# Access Compliance Report

## Public Rights-of-Way

Intersection ID: 53016	Main Street: STEEL_HOUSE_BV	Cross Street: BESSEMER_ST	Location: SE
ADA ID: 32B1F19B86F6	Ramp Type: Perp	Initial Pass/Fail: Pass	Overall Compliance: No
Codes/Mitigation Info/Possible Solution		Field Measurements/Component Compliance	
Severity Score: 10

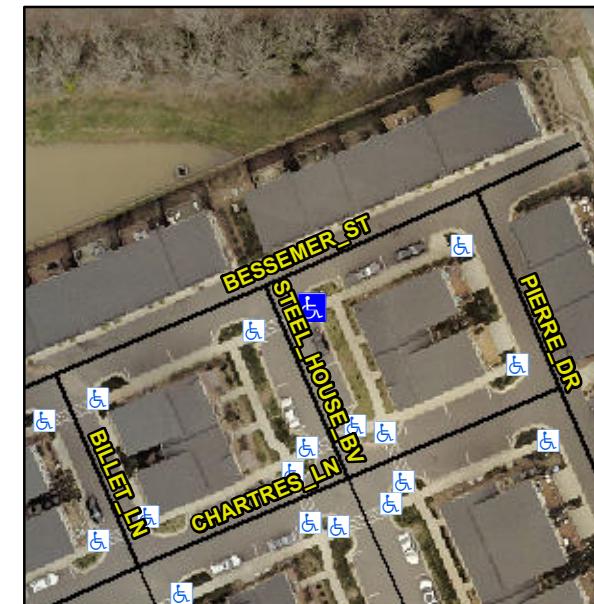
**R304.5.3, R305.1.4, R305.2, R302.7.2**

Compliance	Description	Data	Compliance	Description	Data
N/A	Ramp Length (in)	142.0	Yes	Ramp Slope (%)	6.0
Yes	Ramp Width (in)	60.0	Yes	Ramp XSlope (%)	1.3
N/A	Flare Type LT	None	N/A	Flare Type RT	N/A
N/A	Flare Slope LT (%)	N/A	N/A	Flare Slope RT (%)	N/A
N/A	Flare Traversable LT?	N/A	N/A	Flare Traversable RT?	N/A
Yes	Landing Length (in)	60.0	Yes	DWS Provided?	Yes
Yes	Landing Width (in)	60.0	Yes	DWS Contrast?	Yes
Yes	Landing Slope (%)	0.8	Yes	DWS Length (in)	24.0
No	Landing X Slope (%)	4.6	No	DWS Full Width?	No
N/A	Landing Curb? (Y/N)	No	No	DWS Offset (in)	12.0
N/A	Shared Landing?	No			
Yes	Gutter Ponding?	No	Yes	Gutter Slope (%)	2.9
No	Gutter Lip Ht (in)	0.5	Yes	Gutter X Slope (%)	2.0
N/A	Painted X Walk1?	Yes	N/A	Painted X Walk2?	N/A
	X Walk 1 Direction	To SW		X Walk 2 Direction	N/A
N/A	X Walk 1 Width (in)	66.5	N/A	X Walk 2 Width (in)	N/A
	X Walk 1 Slope (%)	0.8		X Walk 2 Slope (%)	N/A
	X Walk 1 X Slope (%)	3.0		X Walk 2 X Slope (%)	N/A

Yes	Ramp inside XWalk1?	Yes	N/A	Ramp inside XWalk2?	N/A
	Road Slope (%)	N/A	N/A	Clear Space?	Yes
	Road X Slope (%)	N/A	N/A	Clear Space to XWalk (in)	N/A
Yes	Any Obstructions?	No	Yes	Storm Grate/Utility Hazard?	No
	Obstruction Type			Storm Grate/Utility Type	
		N/A			N/A
		Yes		Surface Condition? (G/P)	Good

**Remove & Replace Entire Ramp.  
Grind Gutter Lip.**
